TIME DELAY KIT

(WG1A Forced Air Systems)

Figure 1. Delay Timer Wiring Diagram

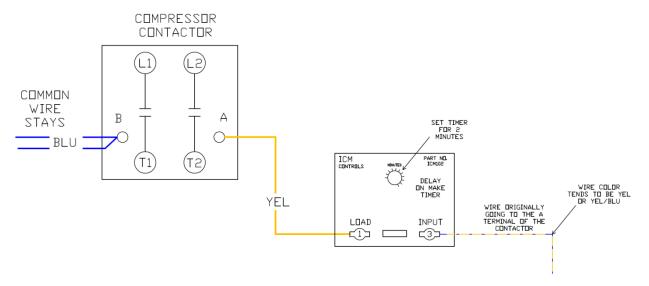
Some WG1A single stage units, those with analog controls, may experience high head pressure or low suction at start up. This is due to the slow ramp up rate some blowers equipped with ECM motors may experience.

This is not an indication of a faulty ECM motor nor an indication of equipment fault. The slow ramp up rate of the blower is purposely programed into the ECM blower controller. Its purpose is to allow a standard air to air heat pump or air conditioner to achieve AHU or cased coil temperature before applying the full set CFM output.

This slow ramp up is not required of Waterless Geothermal equipment as near full capacity is achieved at start up. The slow ramp up rate may cause nuisance lock outs or, possibly a misdiagnosis of a faulty blower motor.

To correct this, Total Green MFG. is providing a delay on make timer kit to be field installed as needed in the compressor unit. Following the supplied wiring diagram and setting the timer for a 2 minute delay allows time for the blower to ramp up before starting the compressor.
